# Bat Specialist Report

## for the final layout of the proposed Msenge Emoyeni Wind Energy Facility

Date: 6 June 2022

Figure 1 IWS' May 2018 GPS tracks (pink) in relation to the final proposed layout of infrastructure for the Msenge Emoyeni WEF

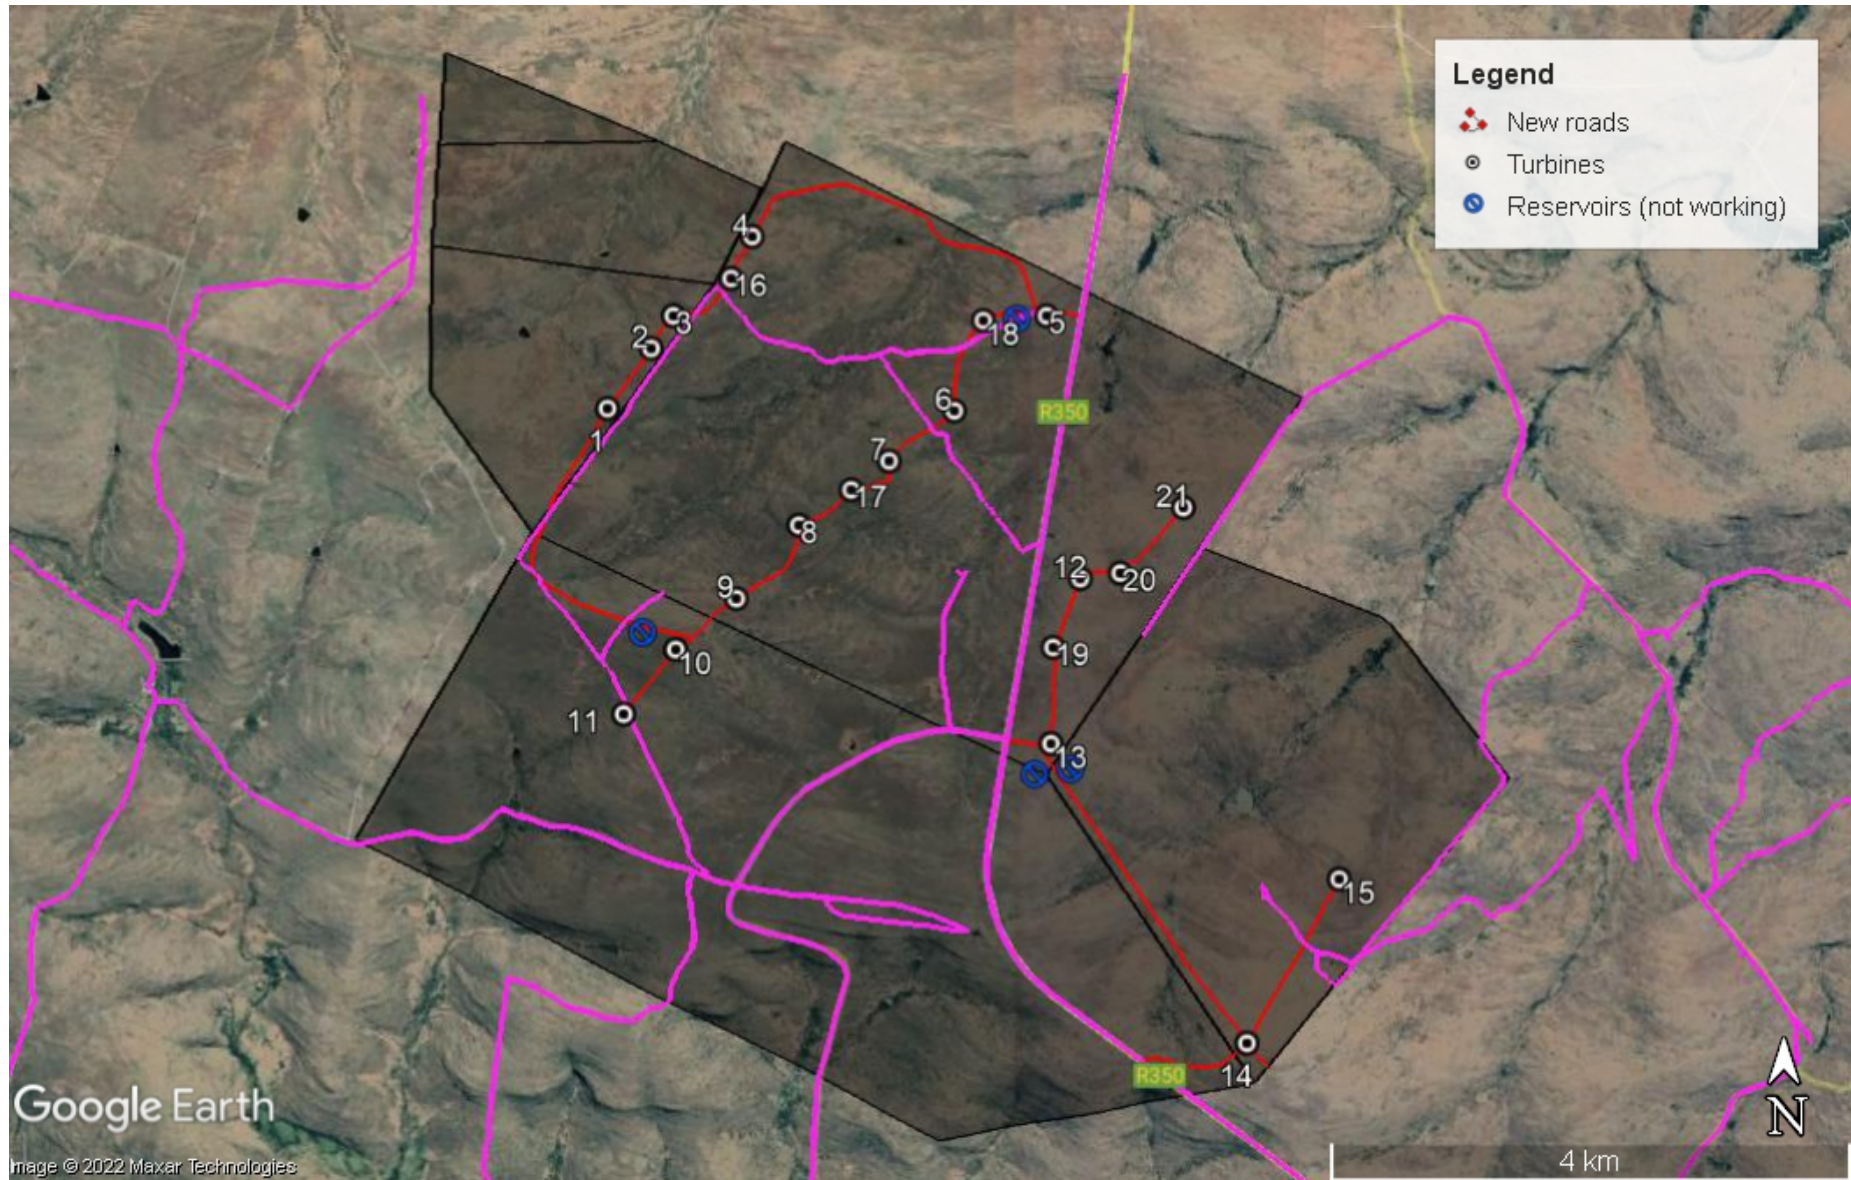
Shown in **Figure 1** are IWS' GPS tracks from the May 2018 walkthrough, in relation to the final layout of turbines for the proposed Msenge WEF. The updated bat sensitivity map for the site is presented in **Figure 2**. Bat sensitivities associated with the 21 proposed turbine positions for the Msenge WEF are summarized in **Table 1**.

Changes to the sensitivity map included the removal of the 200 m High sensitive buffer around each of four farm reservoirs, based on confirmation from the relevant landowners or occupants (Nick Bowker, Michael Jeggens, and Morne Pietersen pers. comm. May 2022) that these reservoirs no longer retain water (**Figure 1**).

Figure 2 Updated bat sensitivity map for the proposed Msenge WEF

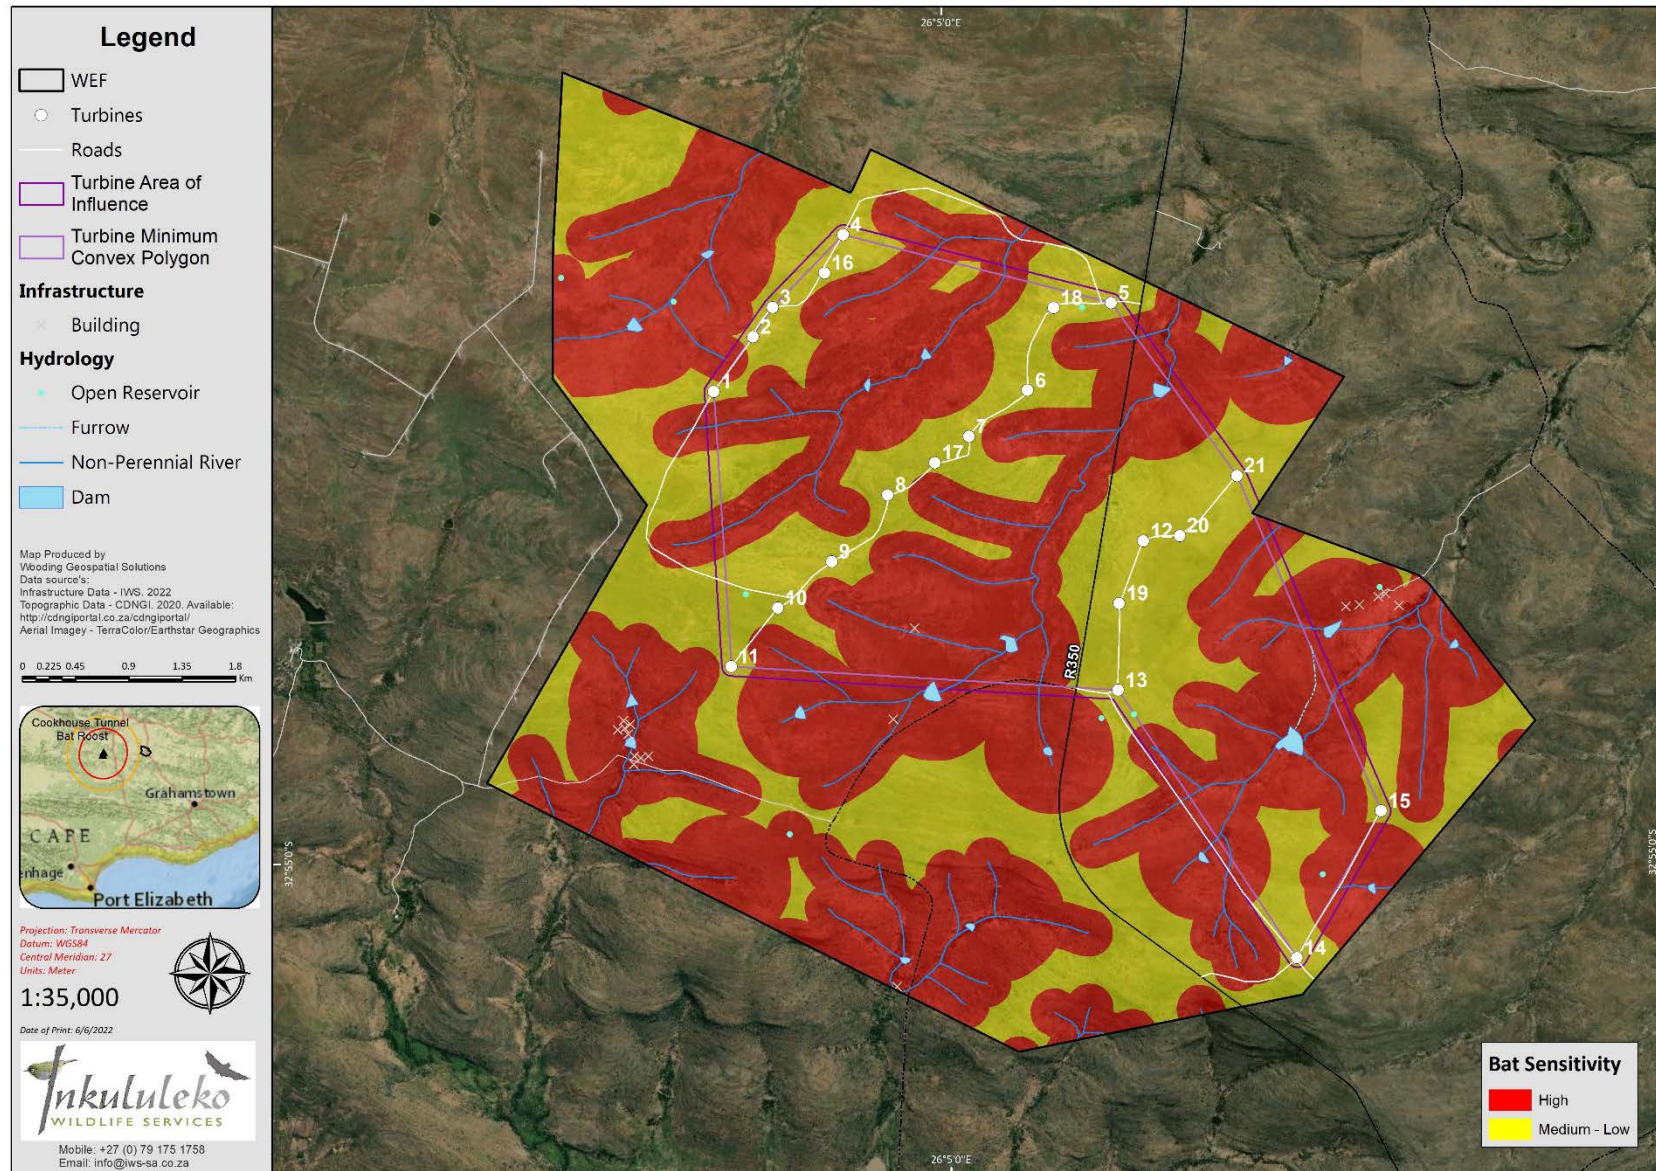
At all 21 proposed turbine positions, the turbine bases and (maximum 80 m) blades will be wholly situated in Medium bat sensitive areas. Therefore, the 21 proposed turbine positions may remain unchanged from a bat impact perspective.

The Msenge WEF site is situated in the Drakensberg Montane Grasslands, Woodlands, and Forest ecoregion and since the 21 x 80 m-blade turbines will have a 1 866 ha Area of Influence as shown in **Figure 2**, the bat fatality threshold for this WEF has been calculated according to the MacEwan *et al.* (2018) guidelines as:

0.2 bat fatalities for every 10 ha x 1 866 ha / 10 ha = 37.32 bat fatalities per annum
